BEFORE THE HEARING COMMISSIONERS

of a subdivision to create 242 residential lots within the C2 Growth Cell, and associated lots for public assets by 3MS of Cambridge GP Limited (SP/0179/20)

STATEMENT OF EVIDENCE OF JIMMY JIENAN ZHUANG (Urban Design)

Dated: 18 May 2021

| UD0101 | A |

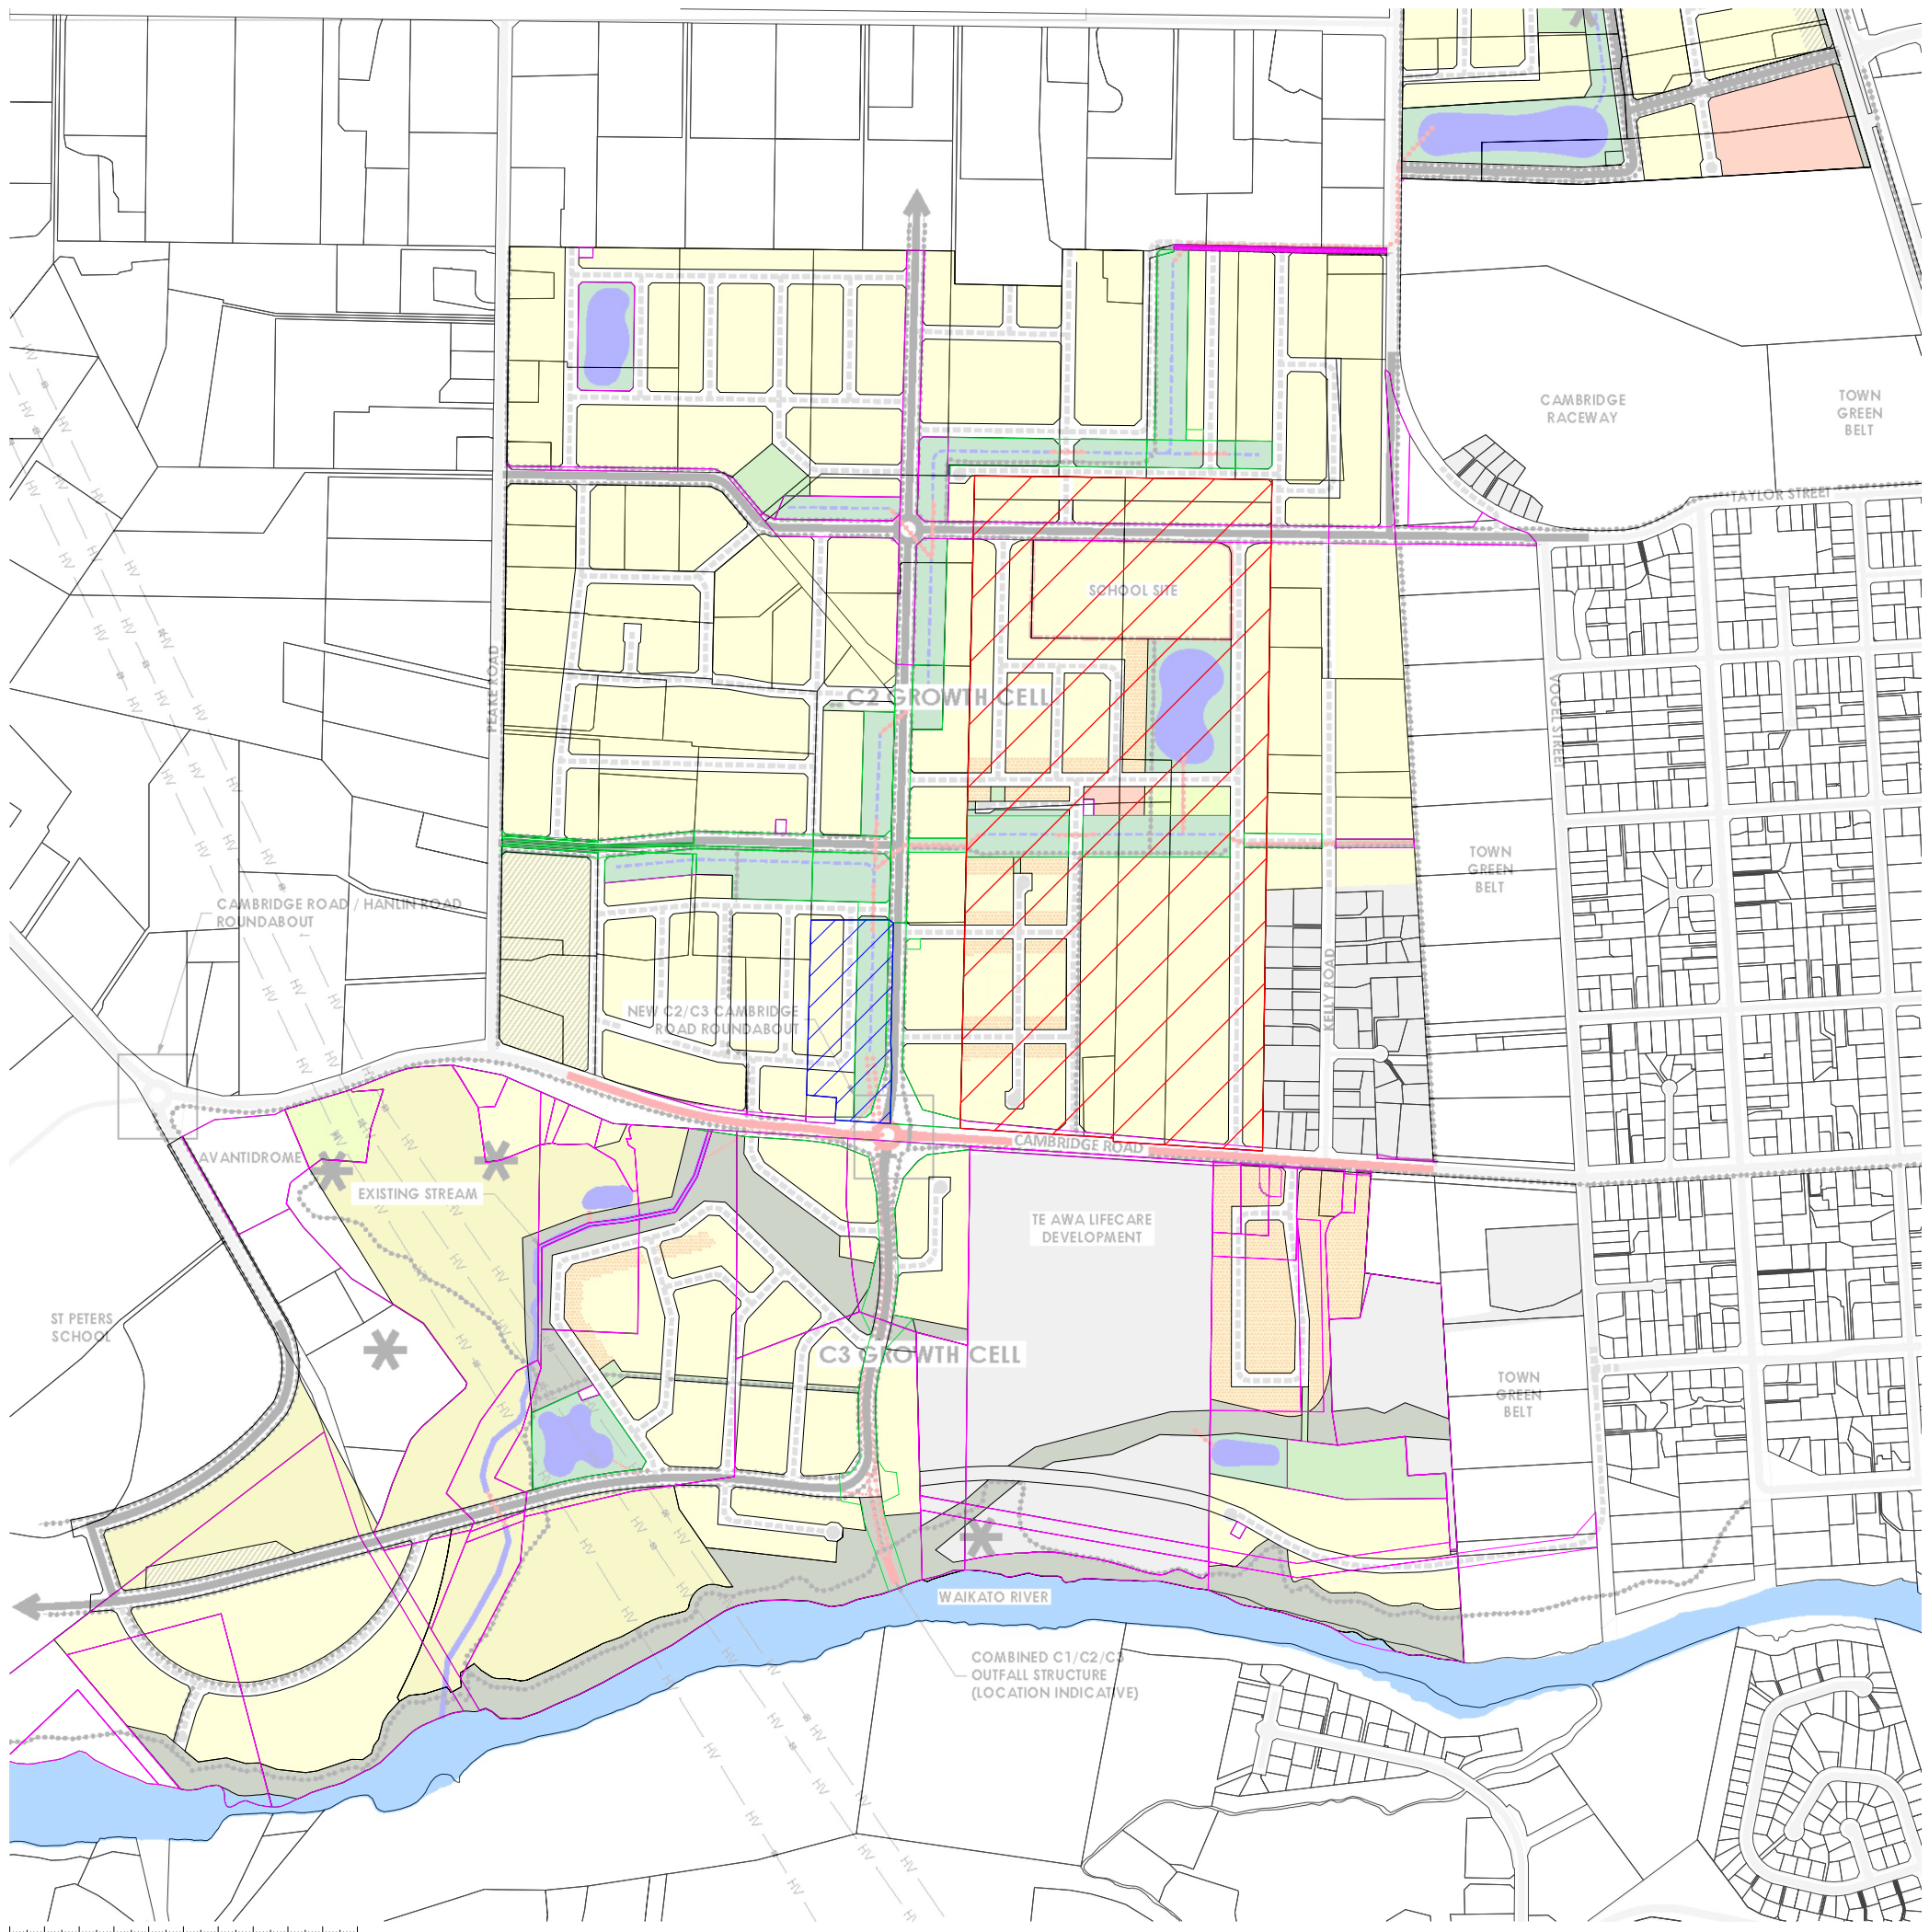
- a. the proposed relocation of the Open Channel Green Space from within Stage 1 to Stages 2 and 3
 - i. the entire width of Open Channel Green Space, approximately 44.3m wide, was placed on Submitter 4's land between Cambridge Road and the northern boundary of the Submitter 4's land (refer to **Table 1** and **Drawings – UD0101, UD0102**)

- ii. the Open Channel Green Space occupies approximately 11,660m² land area of the Submitter 4's land (refer to **Table 1** and **Drawings – UD0101, UD0102**).

- ii. the Collector Road occupies approximately 3,468m² land area of the Submitter 4's land (refer to **Table 1** and **Drawings – UD0101, UD0102**).

SHEET NUMBER
 UD0102

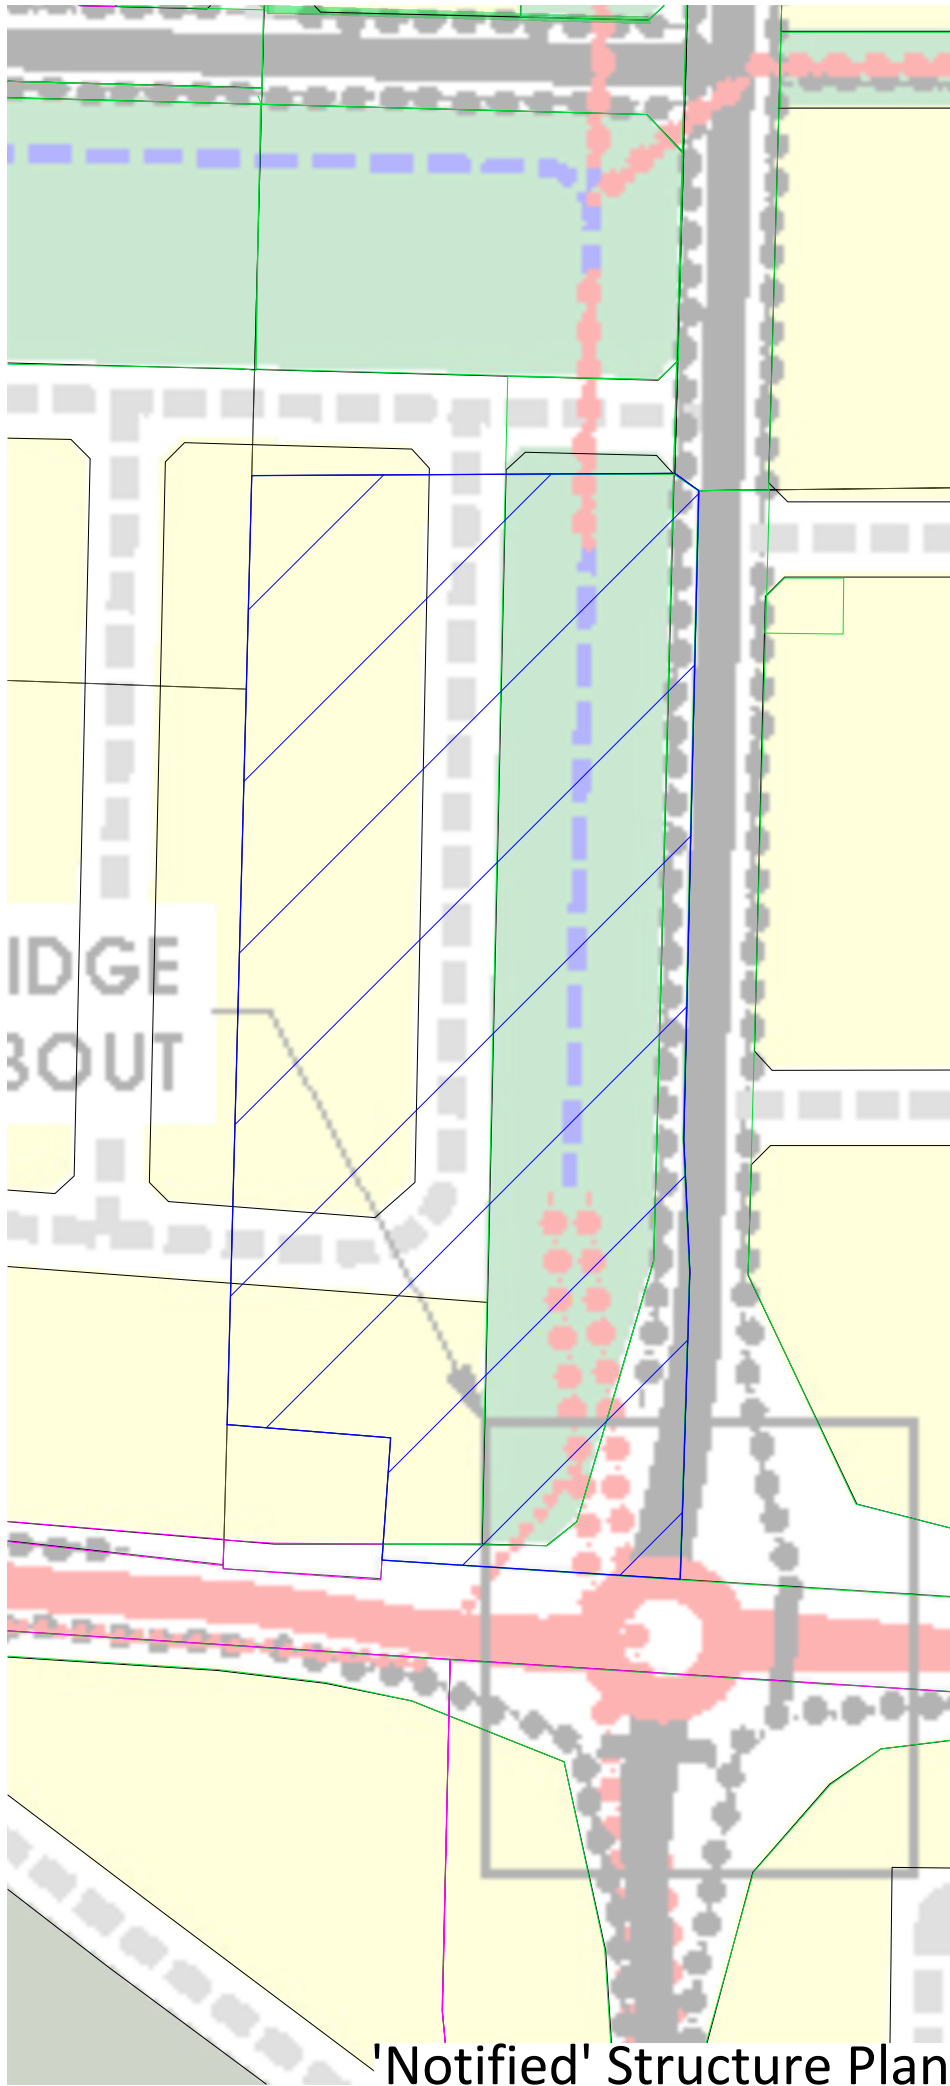
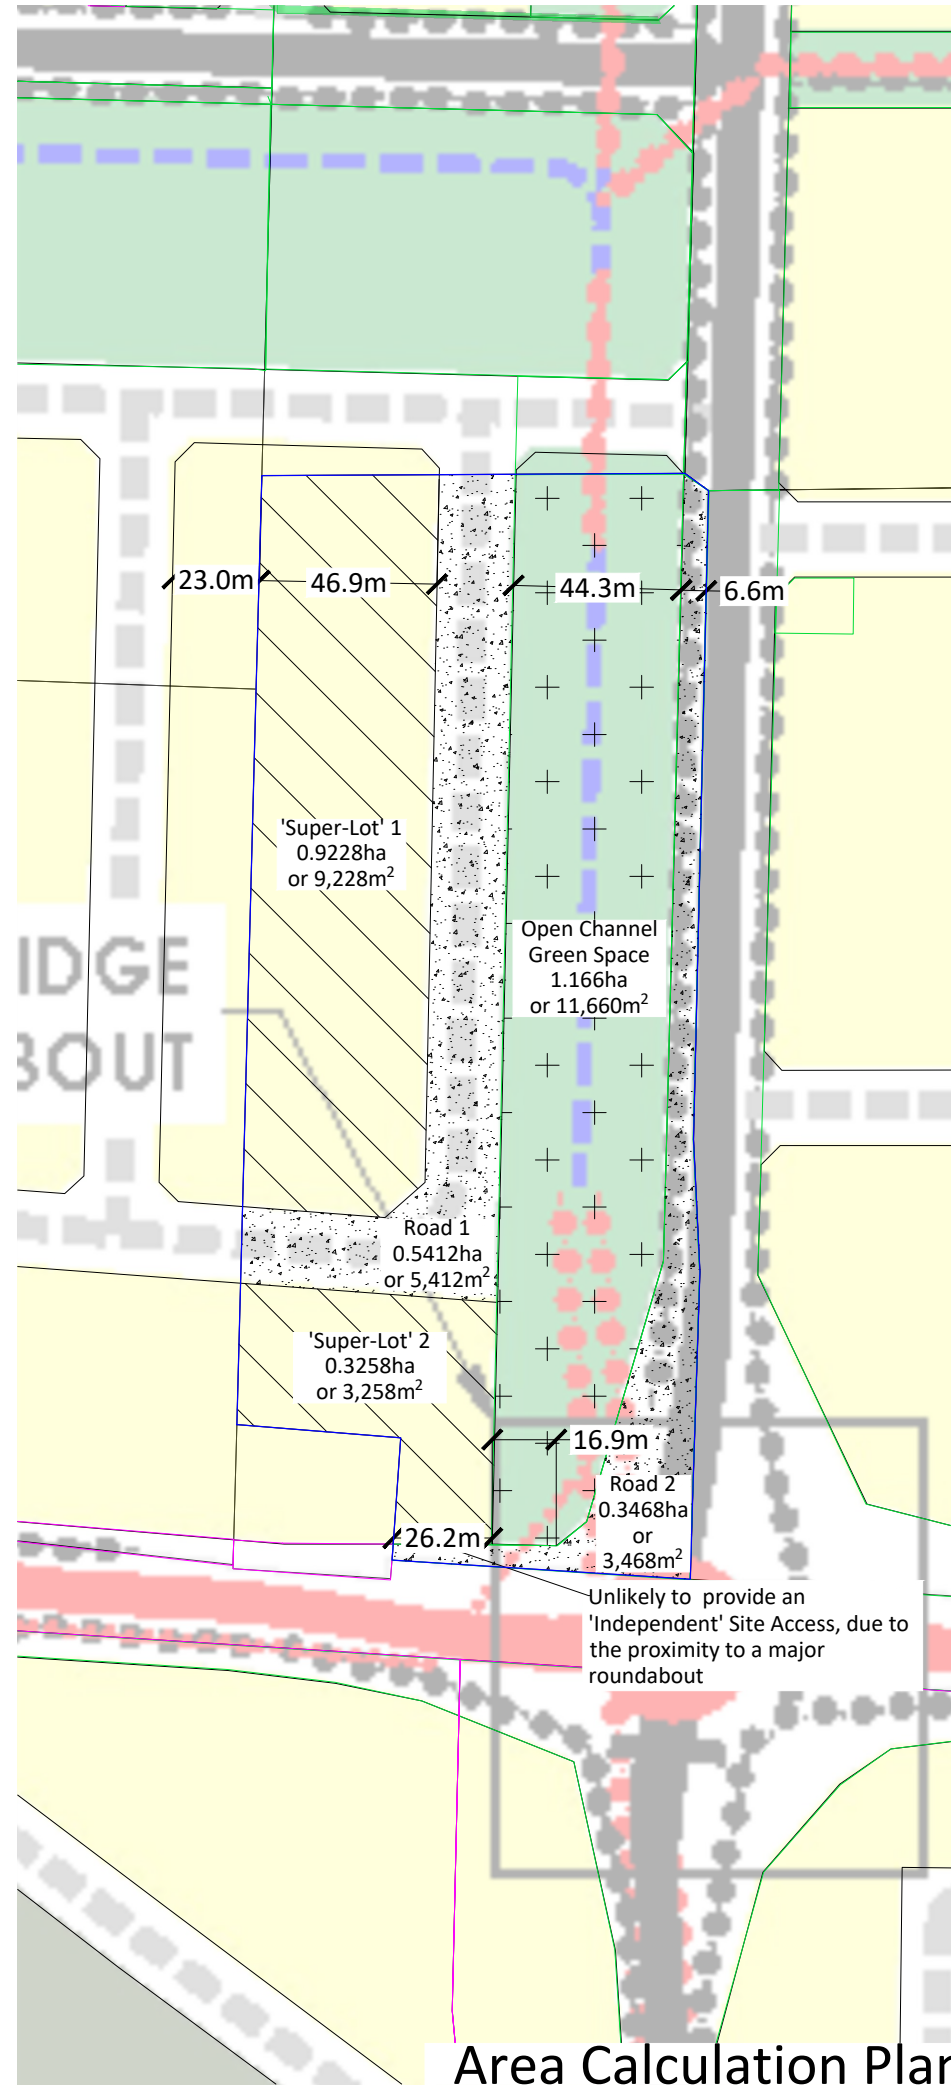
- 5.3. For instance, there are two proposed east-west local roads intersecting the Collector Road, directly to the east of Submitter 4's land, in the Notified Version (refer to **Drawing – UD0102**). Meanwhile, a local road is proposed along the northern boundary of Submitter 4's land, in both the Structure Plan and the Notified Version. Therefore, two T-junctions in very close proximity have to be created. One of the T-junctions will be out of the Applicant's control.

the developable land area, the placement of the Open Channel Green Space in conjunction with a local road significantly adversely affects the remaining 'super-lots' shapes and dimensions (around 46.9m deep, refer to **Drawing – UD0102**), as well as their potential and efficiency of residential lot development.
